TRUCK, GENERAL MAINTENANCE, LIGHT, WINCH, MC2 - LANDROVER 110 6X6

INSTALLATION OF A MAINTENANCE MODULE BATTERY ISOLATION SWITCH AND AN AUXILLARY ALTERNATOR CHARGE INDICATOR LAMP RELAY

MODIFICATION INSTRUCTION

3. **Authority.** Engineering Change Order (ECO) LTB 026/06 is the authority to carry out this modification.

Figure 3 Black Earth Cable to be Disconnected and Wires to Cut

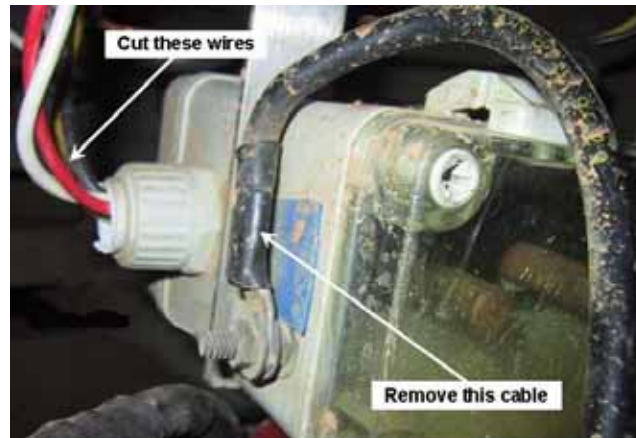
- f. Cut all the wires passing out of the cable gland on the side of the junction box (Figure 3).
- g. Identify the brown 12-volt ignition wire connected to one of the relay coil terminals in the junction box (Figure 4).

Figure 4 12-volt Vehicle Ignition System Wire

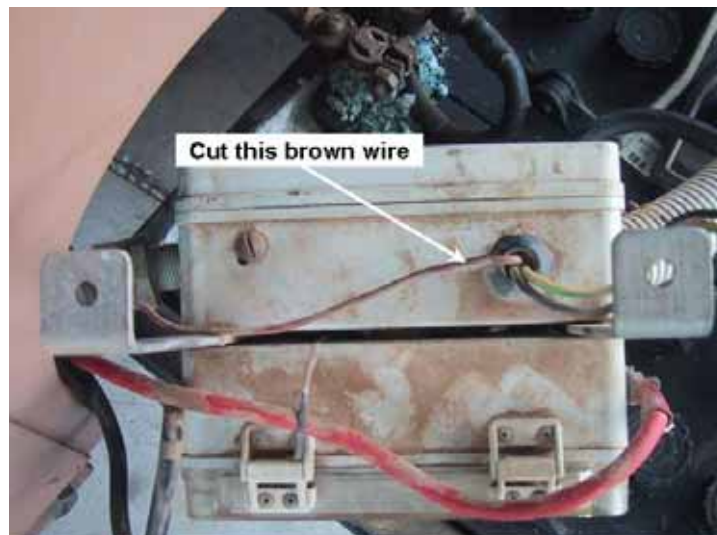
- h. Cut this wire near the junction box.

Figure 5 24-volt Auxiliary Alternator Charge Indicator Lamp Relay Circuit

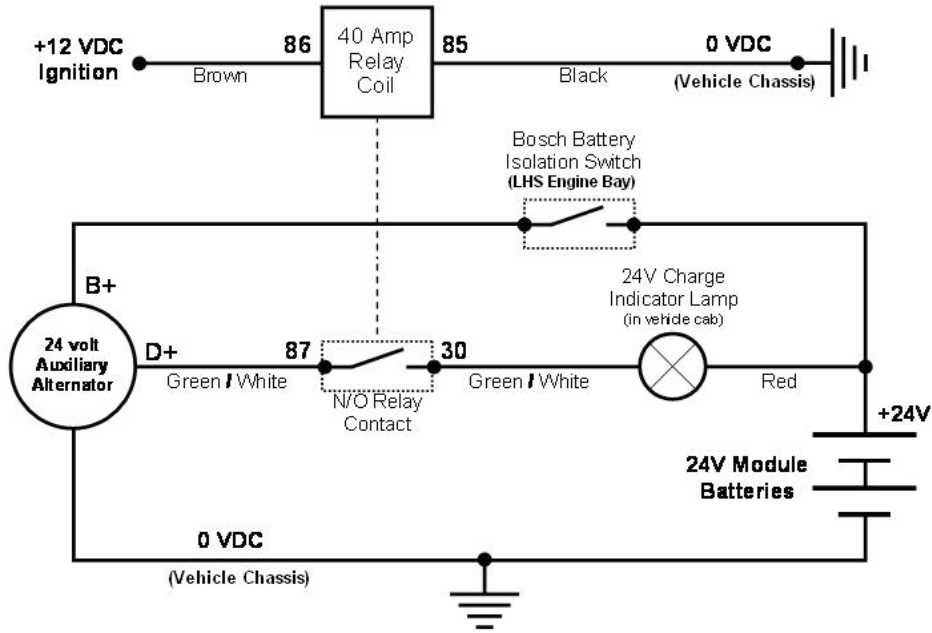
The original 24-volt auxiliary alternator charge indicator lamp relay and associated wiring were part of the junction box and jumper terminals assembly removed at paragraph 12. A new miniature relay fitted in the vehicle engine bay and wired as shown in Figure 5, replaces the original relay.

- l. Cut the green/white wire in the middle of the exposed section and fit an insulated quick connect terminal (Table 1, Item 13) to both ends.
- m. Connect these two connectors to terminals 87 and 30 on the relay so that the relay contacts are now in series with the wire (Figure 5).
- n. Cut a length of 4 mm² black wire (Table 1, Item 18) long enough to connect between the forward mounting bolt of the Bosch battery isolation switch mounted on the left hand chassis rail and the new relay mounted on the guard arch.
- o. Fit an M10 insulated ring terminal (Table 1, Item 12) on one end of the wire and an insulated quick connect terminal (Table 1, Item 13) to the other end.
- p. Connect the ring terminal end of this wire to the isolation switch mounting bolt as shown in Figure 9.

Figure 8 24-volt Auxiliary Alternator Connections

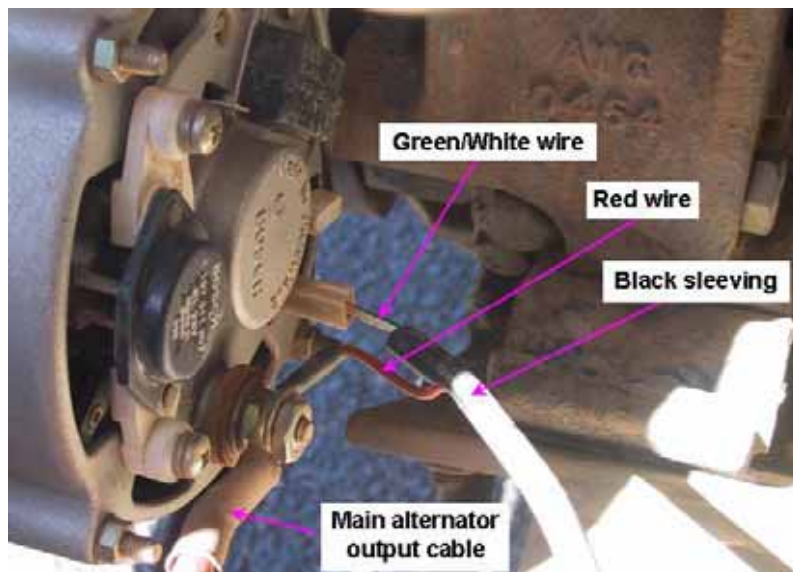
- e. Mount the Hella 12-volt automotive relay (Table 1, Item 3) using an M6 x 20 mm bolt (Table 1, Item 6), M6 flat washer (Table 1, Item 10) and an M6 self-locking nut (Table 1, Item 8). Fit the washer and nut on the underside of the wheel arch.
- f. Hand-tighten the mounting bolt until all the wiring connections to the relay have been completed.
- g. Cut the brown ignition wire drawn back into the engine bay in paragraph 13.c. so that the length of wire still attached to the vehicle loom is long enough to connect to the relay in its mounted position.
- h. Fit an insulated quick connect terminal (Table 1, Item 13) and connect the wire to terminal 86 on the relay.
- i. Identify the red (B+) wire and the green/white (D+) wires (Figure 8) that are sheathed together and connected to the 24-volt auxiliary alternator in the engine bay.

- j. Follow the black sleeving covering these two wires back from the alternator to a point adjacent to the new relay.

Figure 10 Wiring Diagram Showing the New Module Battery Isolation Switch

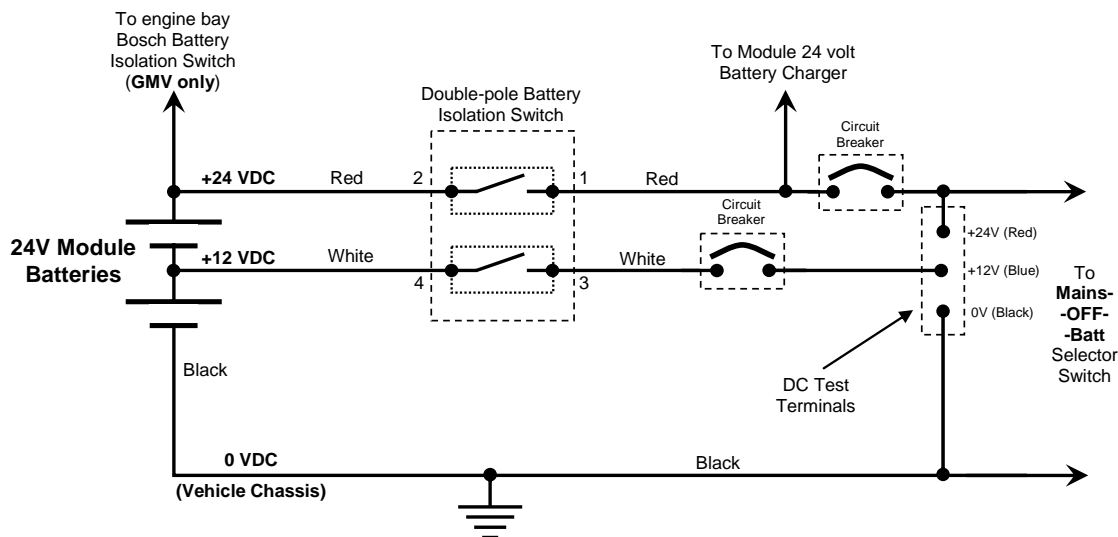
The new module battery isolation switch is to be fitted above and to the left of the module battery carrier so that its T-bar handle can be easily reached and operated when the battery carrier is in the fully retracted position and the battery cover is fitted. The switch is a twist-to-operate double pole type with a T-bar operating handle that enables both the 12-volt and the 24-volt dc supplies to be isolated from the maintenance module wiring as illustrated in the wiring diagram shown in Figure 10.

Figure 12 Mounting Brackets

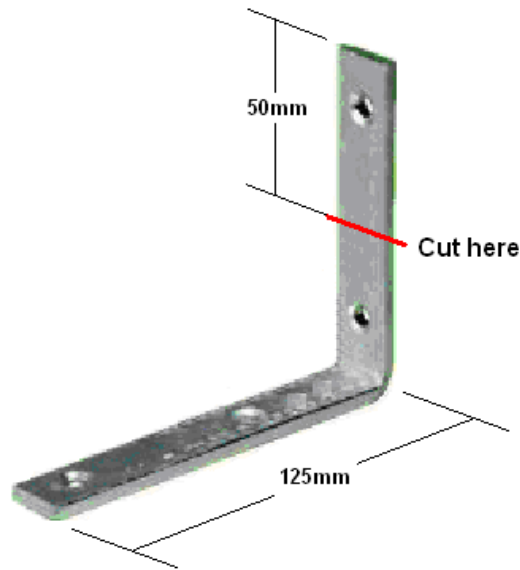
- b. Cut 50 mm off the short leg of each of the two isolation switch mounting brackets (Table 1, Item 4) as shown in Figure 12.
- c. Position the two isolation switch mounting brackets beneath the module floor over the holes drilled in para 14.a. with the long legs facing down and as close as possible to the angle frame member below the floor (Figure 13).
- d. Secure the brackets with an M8 x 40 mm button head bolt (Table 1, Item 5) and an M8 self-locking nut (Table 1, Item 7). Fit an M8 flat washer (Table 1, Item 9) beneath both the head of the bolt and the nut.

Figure 16 Module Battery Connections

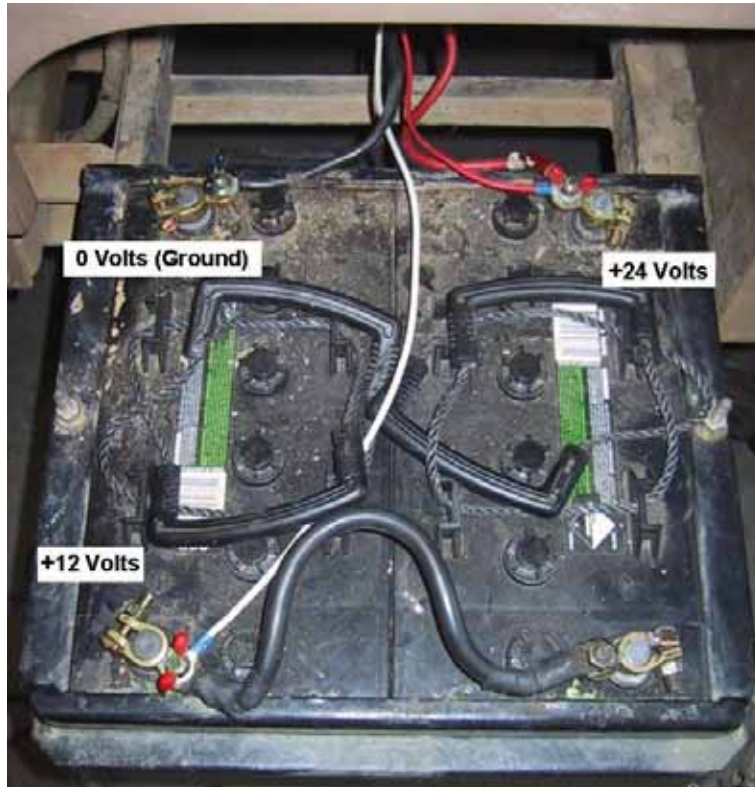
- i. With the battery carrier fully extended, cut a length of 4 mm² white wire (Table 1, Item 17) long enough to reach from the isolation switch (in its mounted position) to the 12-volt connection point on the batteries and a length of 4 mm² red wire (Table 1, Item 16) long enough to reach from the isolation switch to the 24-volt connection point on the batteries (Figure 16).

- s. Connect the red (24-volt) and black (ground) high current alternator cables (these cables were disconnected from the jumper terminals box at paragraph 12.e.) to the battery 24-volt and ground (0-volts) terminals respectively (Figure 16). Where required, fit new battery terminal assemblies (Table 1, Item 20) to the batteries to provide the wing nut tightened connecting points as shown in Figure 16.

Figure 18 Location of the Modification Plate

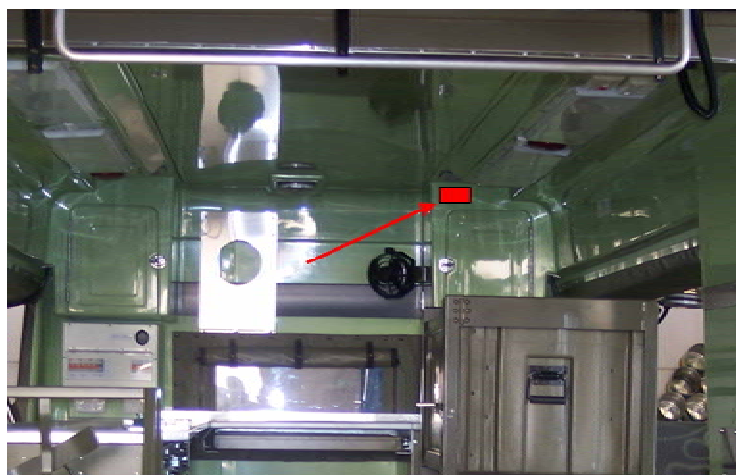
15. Position and secure the modification record plate (Table 1, Item 19) inside the maintenance module in the clear area on the upper right corner of the front interior wall (Figure 18).
